CONSTRUCTION PLANS FOR CARRIAGE MEADOWS SOUTH AT LORSON RANCH

STREET, STORM SEWER, AND POND CONSTRUCTION PLANS

COVER SHEET
STREET, STORM SEWER AND POND
CONSTRUCTION PLANS

SHEET NUMBER **C6.1**

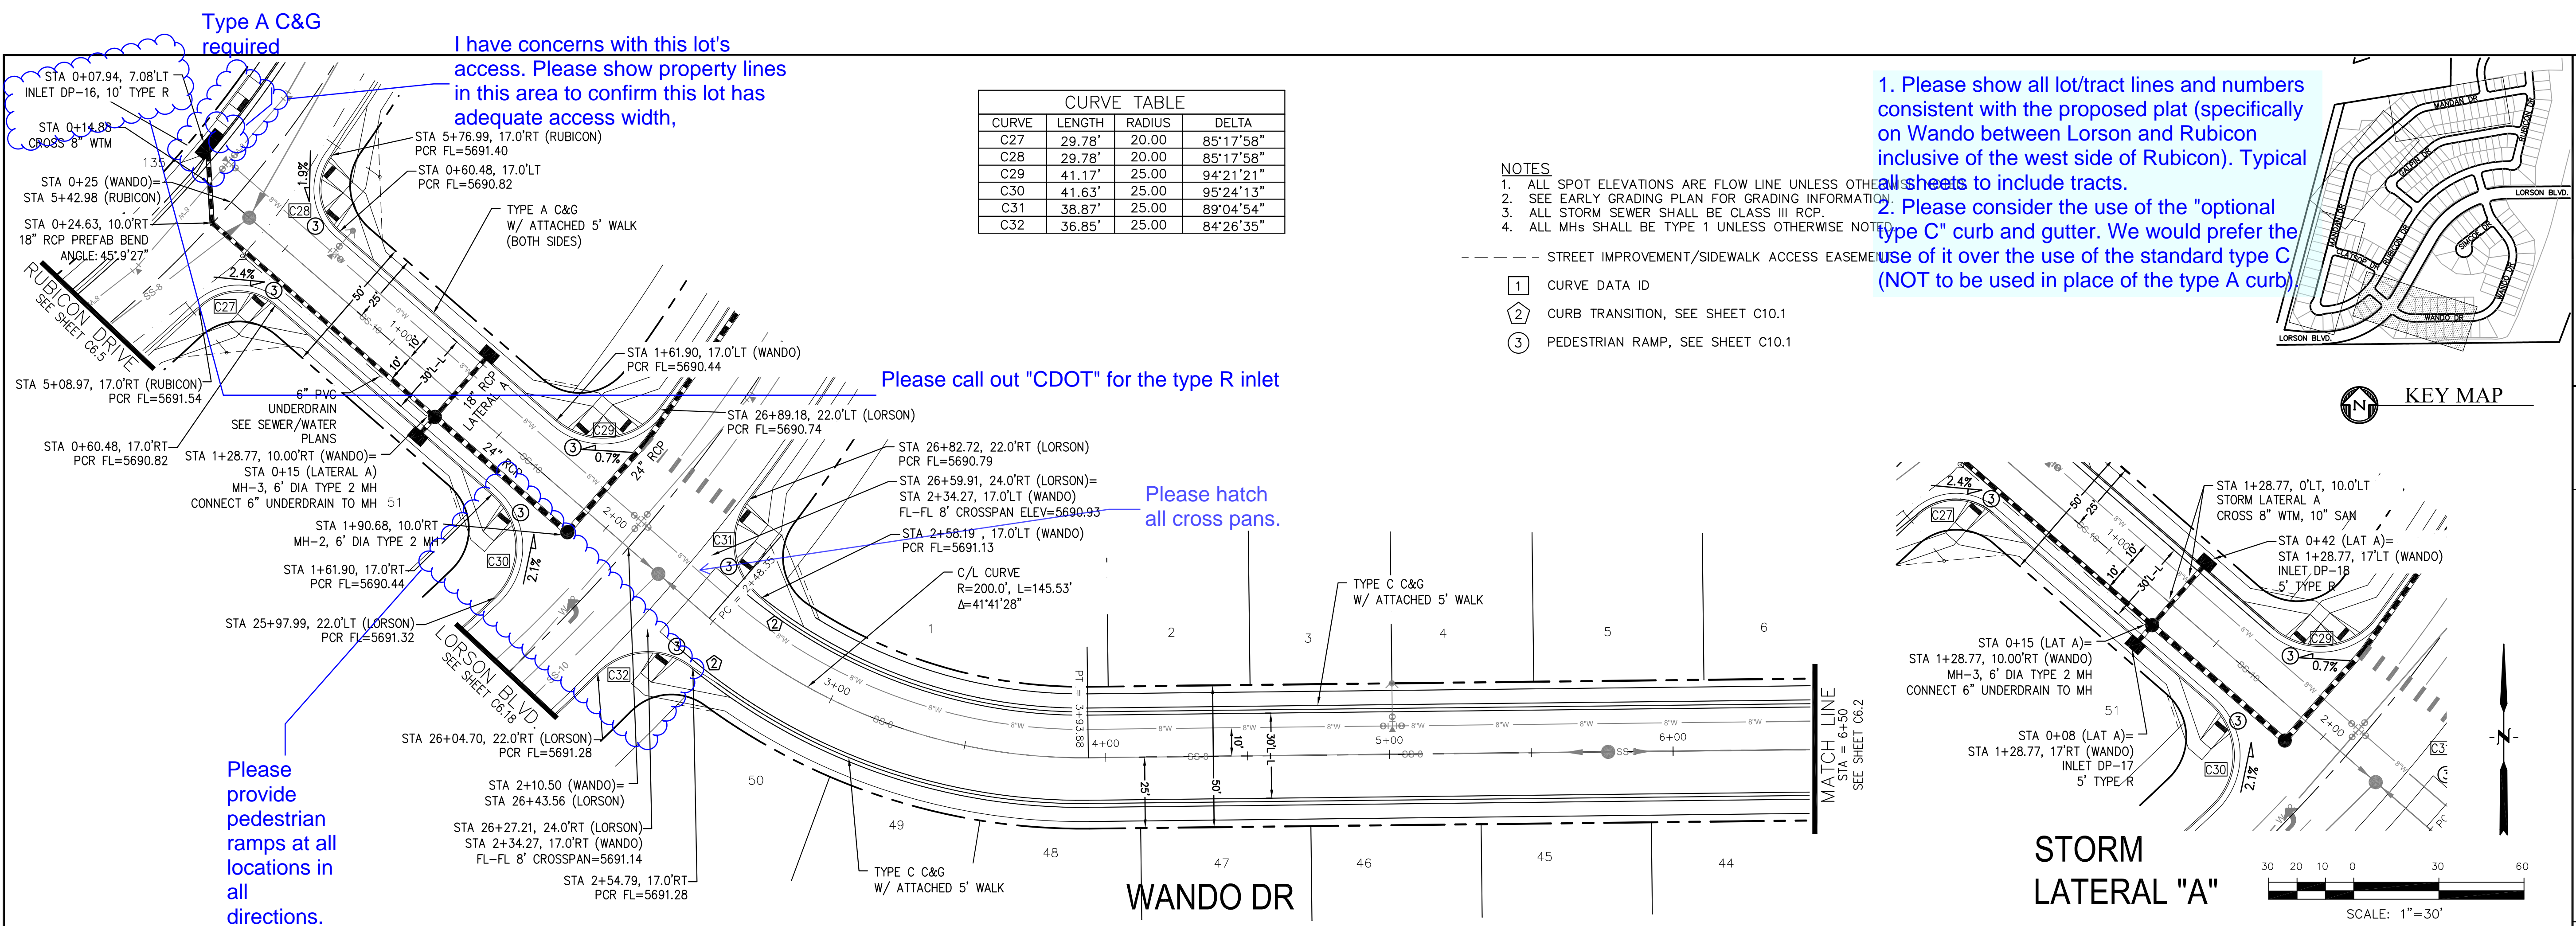
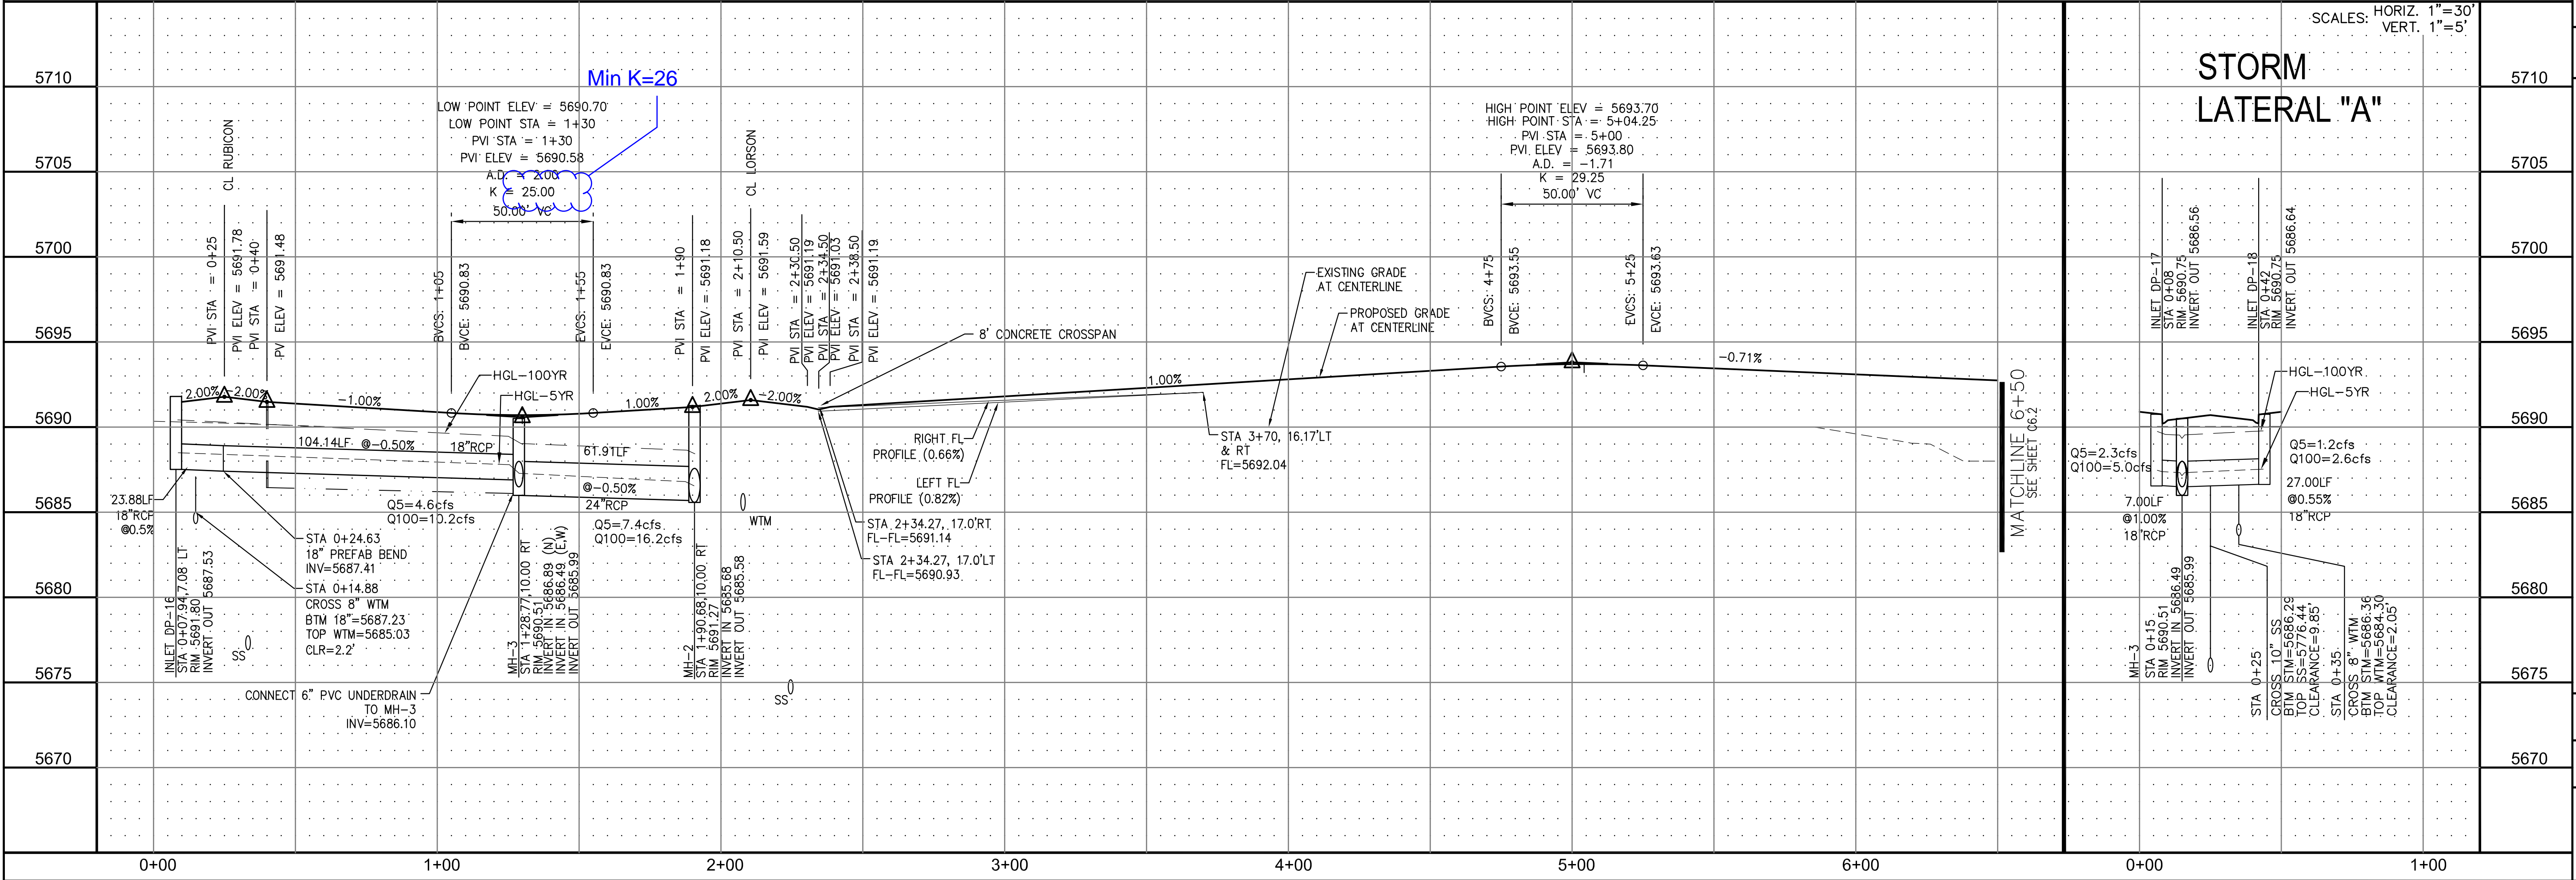
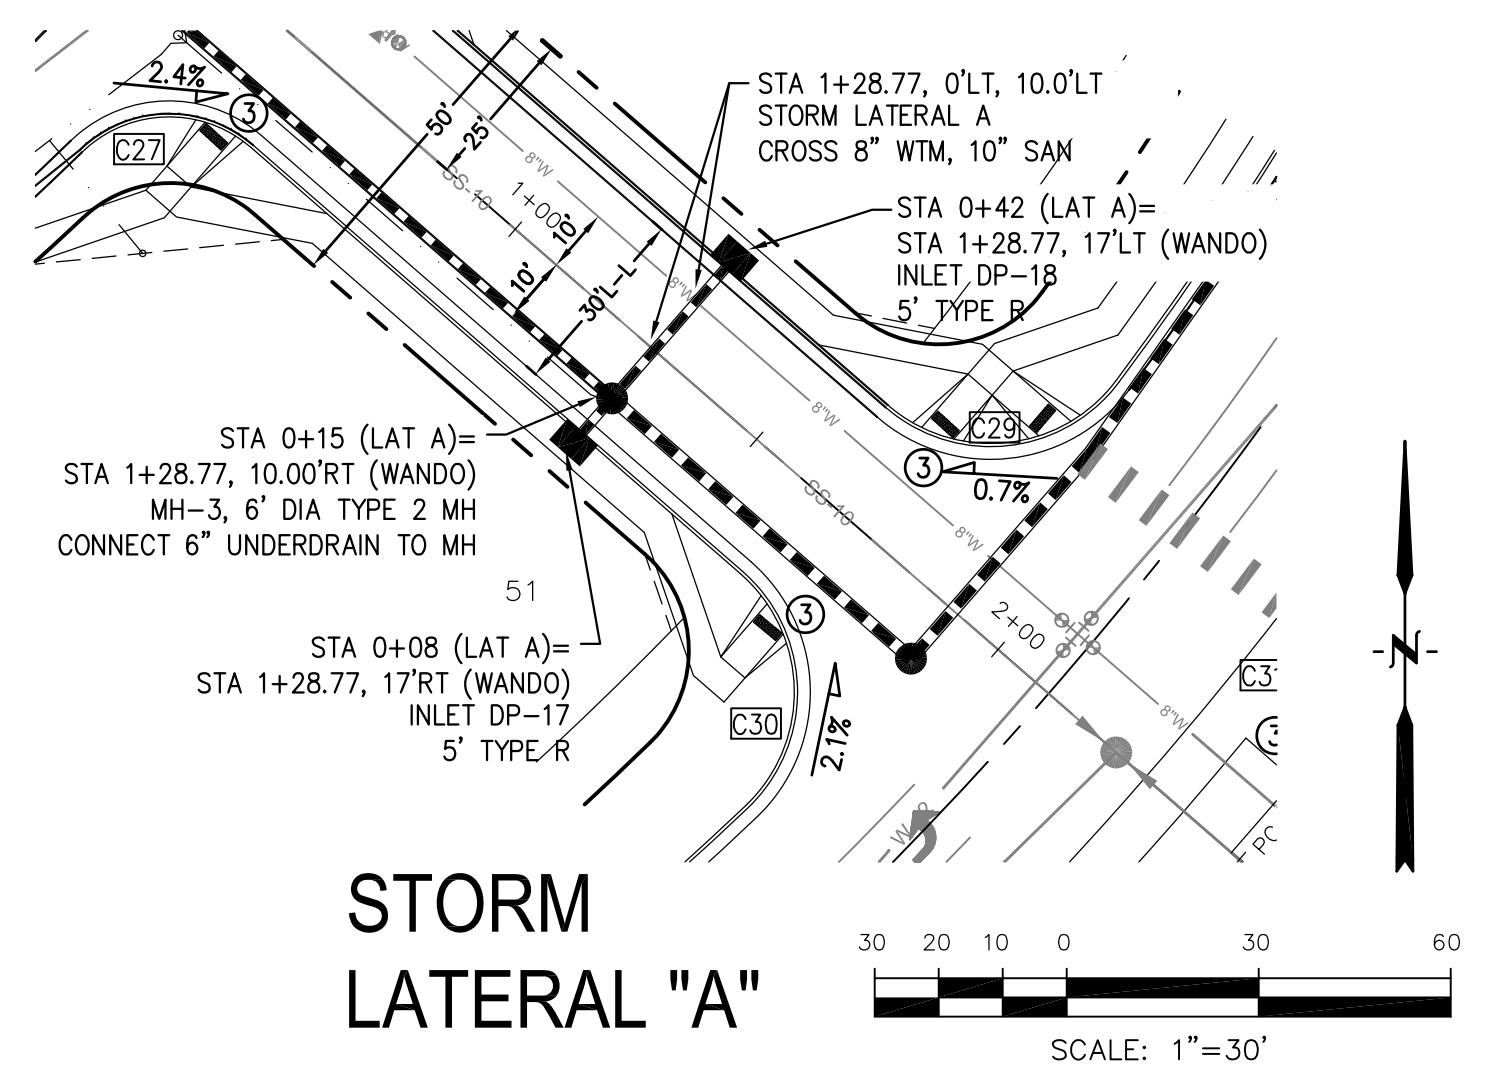
1. Please show all lot/tract lines and numbers consistent with the proposed plat (specifically on Wando between Lorson and Rubicon inclusive of the west side of Rubicon). Typical sheets to include tracts.

2. Please consider the use of the "optional type C" curb and gutter. We would prefer the use of it over the use of the standard type C (NOT to be used in place of the type A curb).

DATE: MARCH, 2017
 PROJECT NO. 100.030
 SHEET NUMBER C6.2
 TOTAL SHEETS: 37

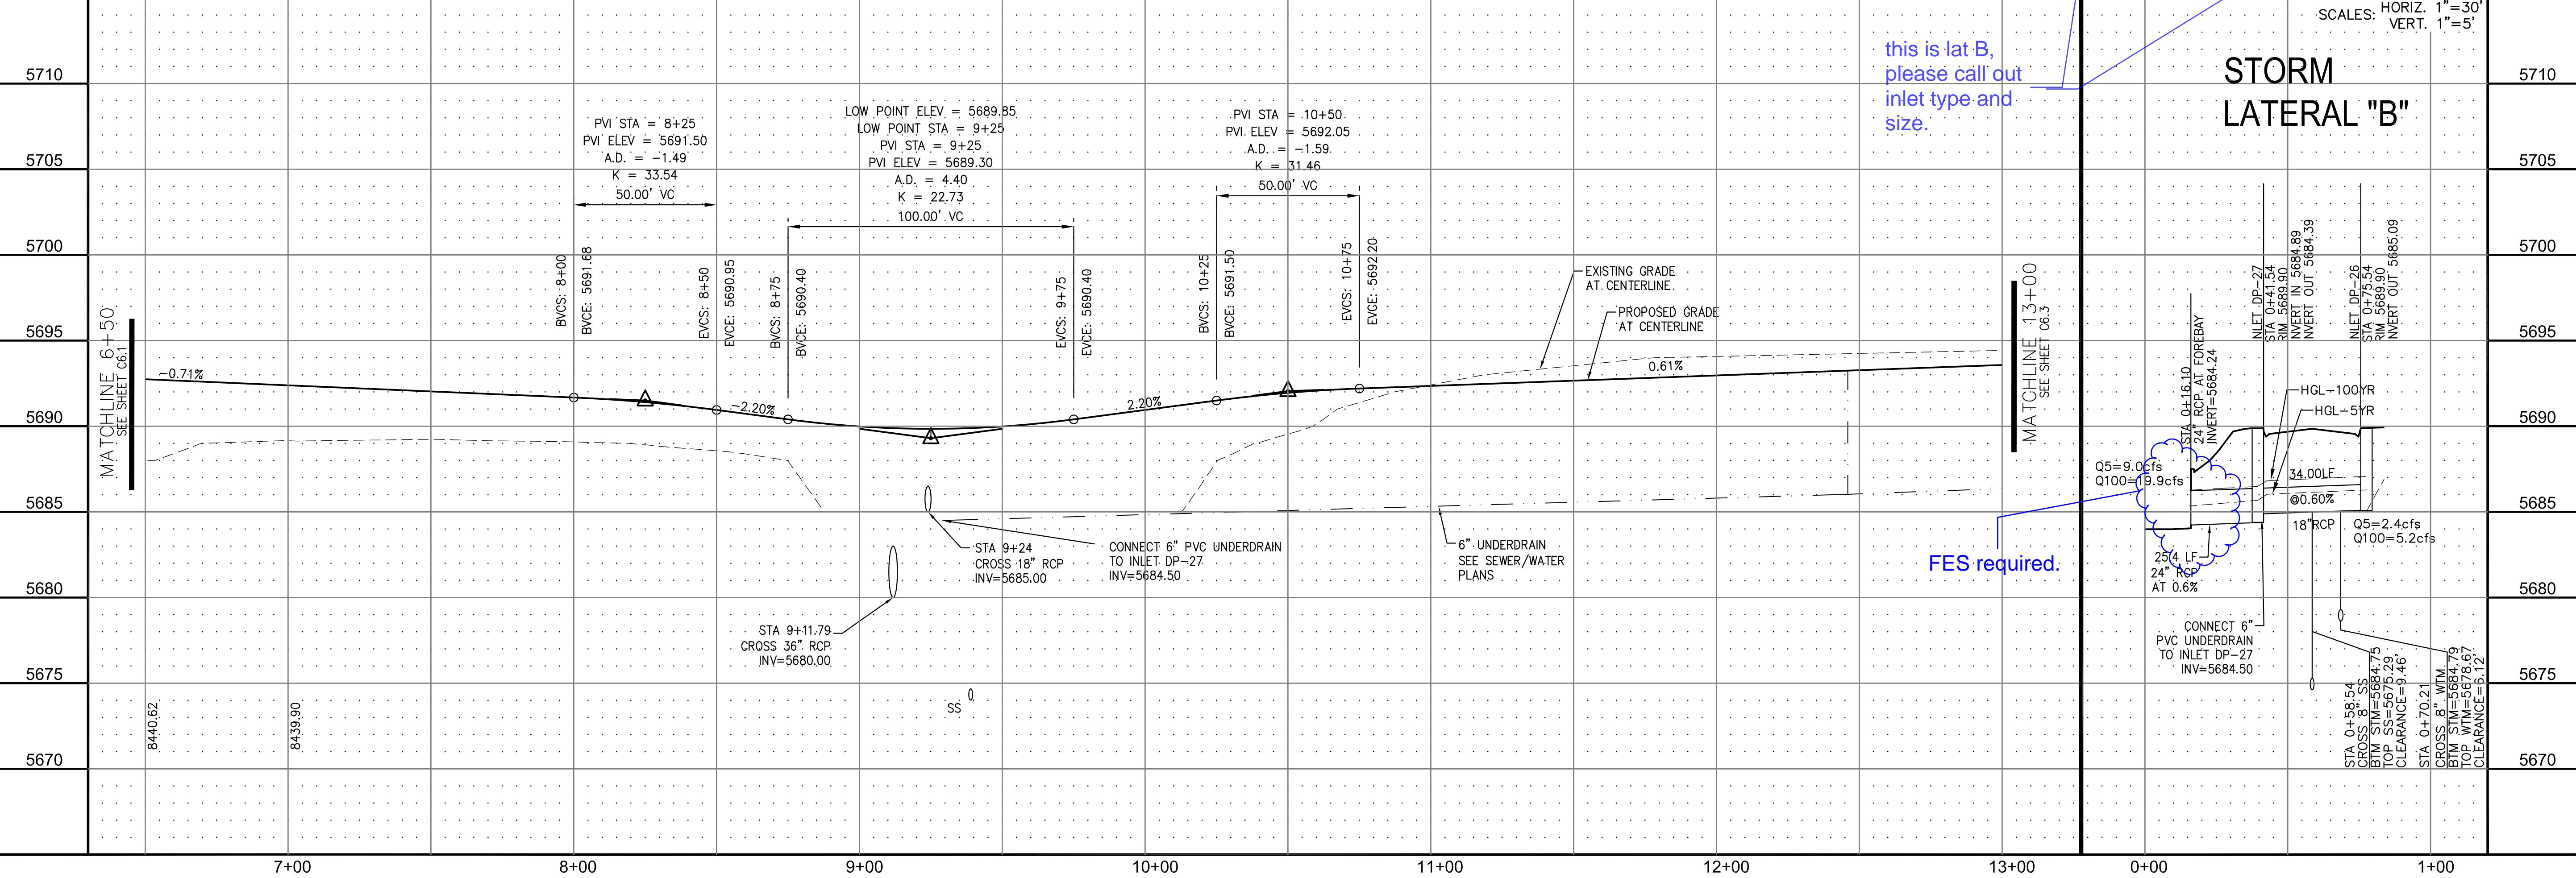
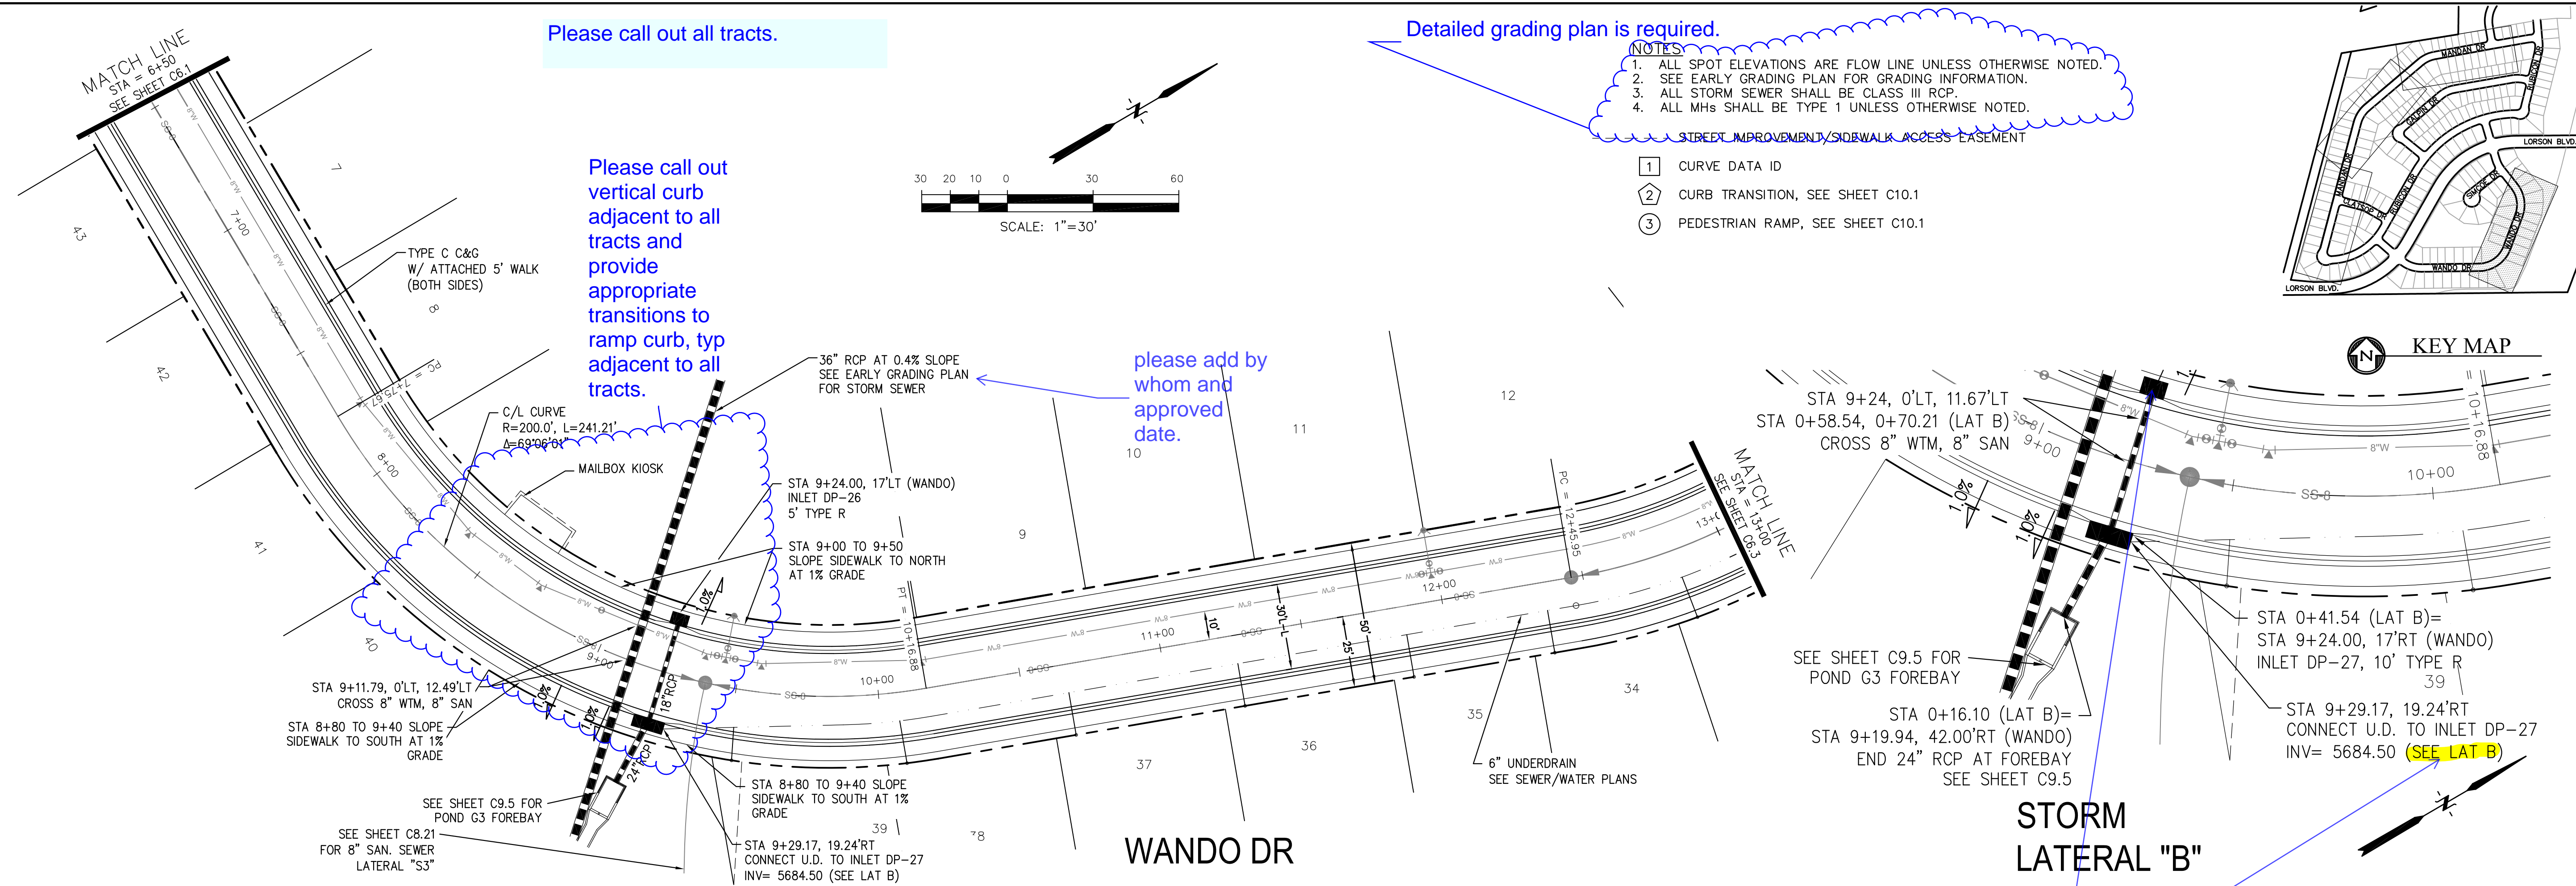
Detailed grading plan is required.

Please call out vertical curb adjacent to all tracts and provide appropriate transitions to ramp curb, typ adjacent to all tracts.

please add by whom and approved date.

this is lat B, please call out inlet type and size.

FES required.
